**BEFORE THE PUBLIC SERVICE COMMISSION  
OF THE STATE OF MISSOURI**

In the Matter of Kansas City Power & Light     )  
Company's 2008 Utility Resource Filing     )     Case No. EE-2008-0034  
Pursuant to 4 CSR 240 - Chapter 22     )

**ENERGY CENTER REVIEW OF**

**KANSAS CITY POWER & LIGHT COMPANY'S**

Figure 1 - KCPL Preferred Plan - Energy Forecast

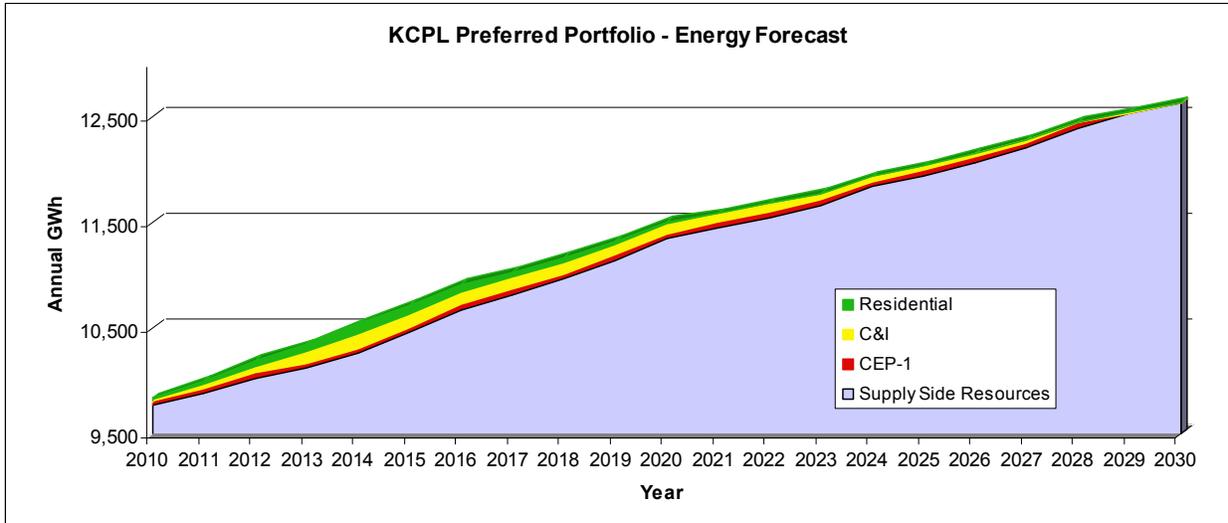
It is significant that at no point do the incremental energy savings exceed 0.58 percent nor do the cumulative savings exceed 2.67 percent of requirements. This table also illustrates the impact of the cessation of DSM programs in 2014 on savings, discussed in detail in Deficiency # 3 below.

Figures 1 and 2 below graphically illustrate the impact of KCPL’s failure on both peak load and energy requirements over the planning horizon.

- Before completion of the SRS process, KCPL should develop and analyze:
  - (i) an alternative resource plan based on Alternative Plan 19 that projects for each year in the 20 year planning period an incremental reduction in energy sales of one percent (1%) resulting from the ongoing implementation of demand side programs; and (ii) an alternative resource plan that similarly projects annual incremental energy impacts of 1.5% throughout the 20 year planning horizon due to DSM programs. KCPL should apply sufficient analysis to the new alternative resource plans to

Figure 3 - Comparative Energy Forecast

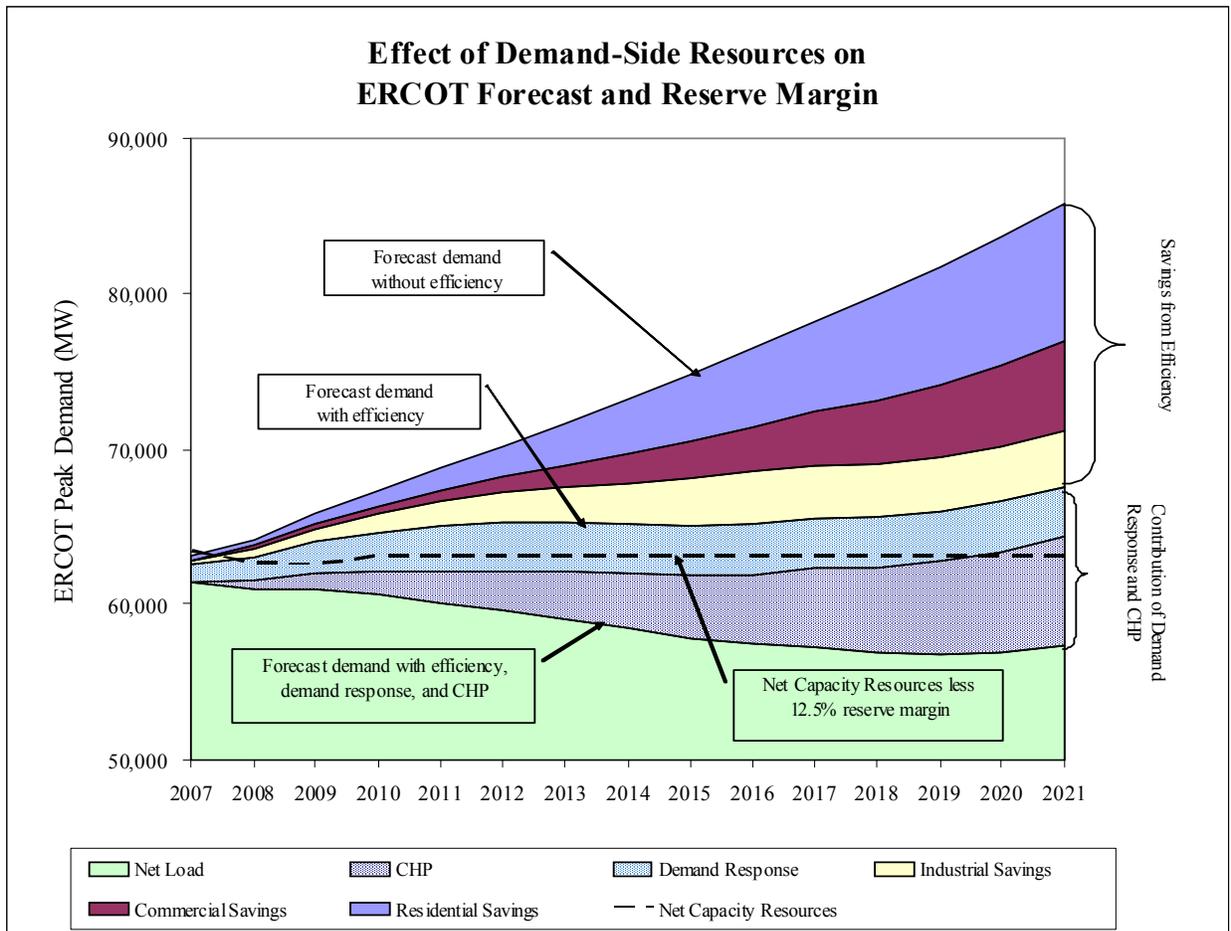
In comparison, Figure 3 below, from a study OEI performed for the state of Texas, represents what is the typical shape of supply forecasts in today’s energy markets.<sup>5</sup>

Figure 4. Residential and Commercial System Targets

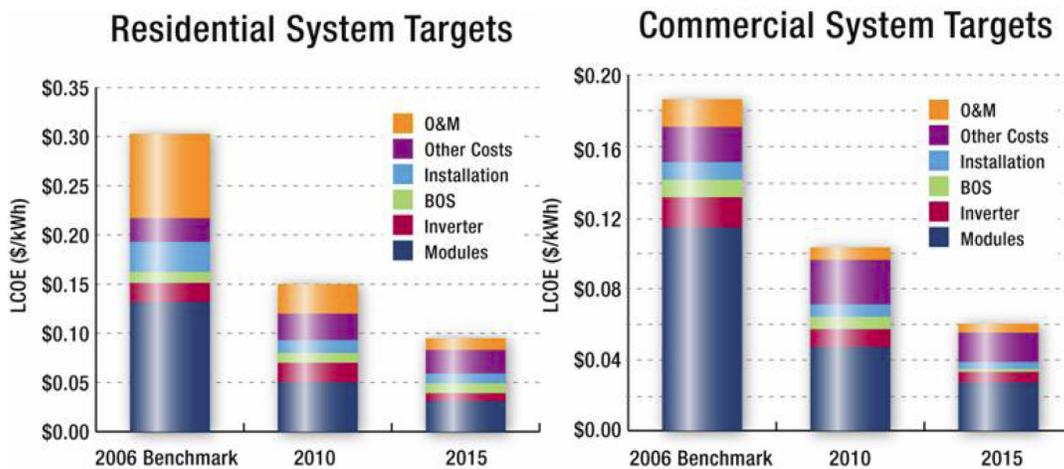
Given the solar set-aside quantity in the Clean Energy Initiative passed by Missouri voters on November 4, 2008, it is important that solar costs are properly reflected in the IRP. The projected costs for solar PV systems used in the IRP are considerably higher than values published by the USDOE Solar Energy Technologies

Program<sup>13</sup>. Given the significant cost differentials between those seen in the USDOE report and the KCPL IRP, it is possible that the solar PV option should not have been excluded from supply-side consideration at the pre-screening stage. The IRP used “low” values of \$9,050/kW (\$2007) and “base” values of \$10,408/kW (Appendix 4.A.7). KCPL per unit PV nominal costs were over 40 cents per kWh. The following Figure 4 is from the USDOE’s 2008 Solar Energy Technologies Program Multi-Year Program Plan, 2008, and shows targets for 2015 and 2020 PV costs of 6 to 10 cents per kWh. The likelihood that the projected cost trends shown here would occur increased with the passage of the November 2008 law, increasing the financial benefits of solar PV through changes to the investment tax credit provisions of the law.

Remedy #8. Prior to its next IRP filing, KCPL should undertake a detailed study of current and projected photovoltaic costs. The study should include the full 20-year planning cycle and should include both utility-scale and customer-sited photovoltaic generation.

In its next IRP filing, KCPL should file updated information on solar photovoltaic costs and as appropriate, incorporate the effect of the newly-legislated solar set-aside in the resource plans evaluated. KCPL should use up-to-date information on solar photovoltaic costs when screening the technology.
